PCN-20190108 TE0807-02-* SPI Flash Change

Company	Trenz Electronic GmbH
PCN Number	PCN-20190108
Title	TE0807-02-* SPI Flash Change
Subject	BOM change
Issue Date	2019-07-08

This change affects Trenz Electronic TE0807-02 SoMs: TE0807-02-*1E

Locate Flash (U7, U17) on bottom side of PCB:

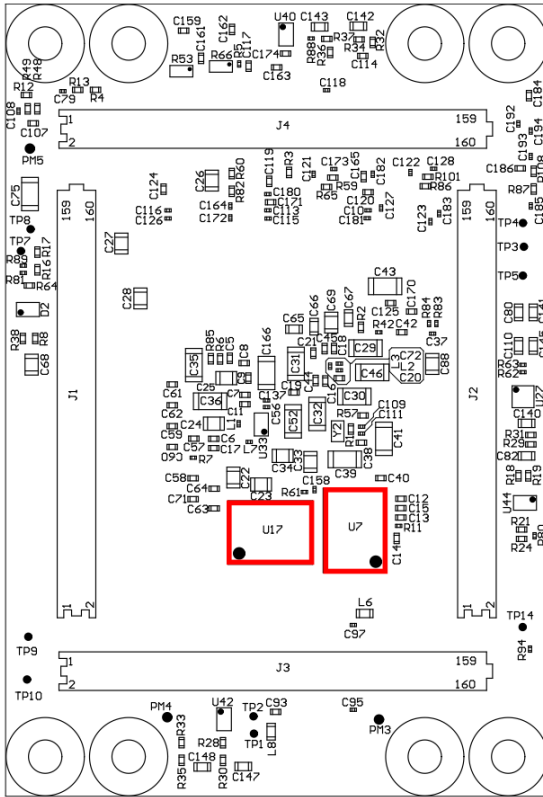
#1 Change SPI Flash from N25Q512A11G1240E to MT25QU512ABB8E12-0SIT

Reason: N25Q512A11G1240E became obsolete.

Impact: None. Both have same JEDEC ID BB20h and manufacturer ID 20h.

old	new
N25Q512A11G1240E	MT25QU512ABB8E12-0SIT
